Deadline 7 submission, 21/7/26

Response to document: “8.4.14 Applicant's Comments on any Further Information or Submissions Received by Deadline 5” [REP6-114]

Figure 1: Tarchon Interconnector Project – indicative onshore HVDC cable corridor⁶

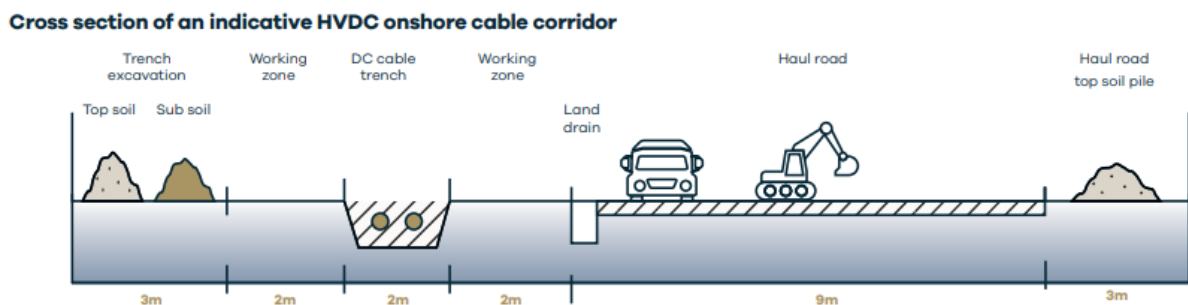
Information presented at the non-statutory consultation in July 2026 for the proposed Tarchon Interconnector Project showed the typical width of a HVDC cable trench to be 2m. A Tarchon representative at the event stated that the typical trench depth would be 1.4 to 1.5m (which aligns with the EGL 3 and EGL 4 project). The relevant image from the display board is provided in Figure 1.

These two additional data sources provide further comparisons with the HVDC trench width of 9.8m and trench depth of 2.1m stated in the Applicant’s drawing “Figure C1” in Annex C of “8.5.3 Applicant’s Written Summary of Oral Submission and Response to Action Points for Issue Specific Hearing 1” [REP1-139].

If the trench width was reduced to 2m, in line with the figure presented by Tarchon (and as also appears to apply to Hornsea 3), the reduction in temporary land take from the HVDC alternative would be significantly greater.

Figure 3: Image from the Applicant’s 2025 Norwich to Tilbury Interactive Map¹¹, showing a section of the proposed underground HVAC route in the Dedham Vale National Landscape. (Annotation added to provide an indication of scale.)

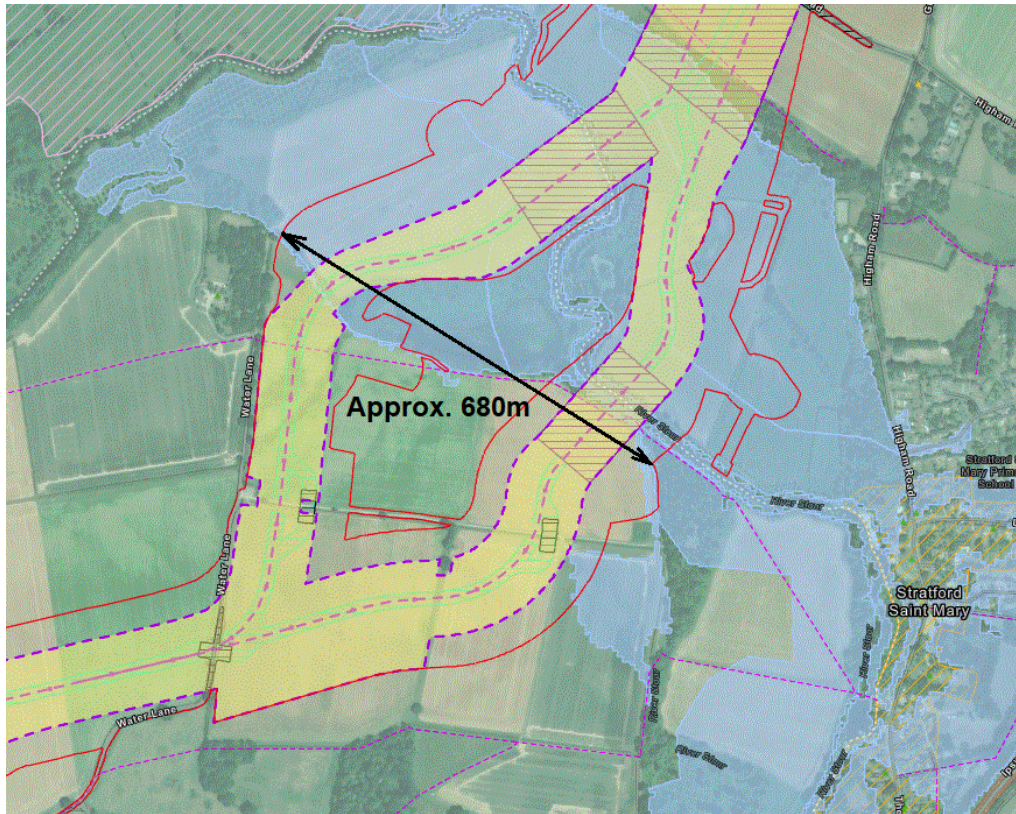
The substantially greater width required for underground HVAC increases the difficulty in navigating constraints and consequently can greatly increase the harm caused. This can be seen in the Dedham Vale National Landscape where it has resulted in the need to split the route in two. The resulting harm would be spread over a considerable area, as can be seen in Figure 3. The image was copied from the Applicant’s 2025 Norwich to Tilbury Interactive Map, with one dimension relating to the order limit separately added to provide an indication of the scale. The scale also becomes apparent when viewed against the size of houses, fields, the River Stour and other features that can be identified in the image. This route alignment requires a haul road in each of the two branches.
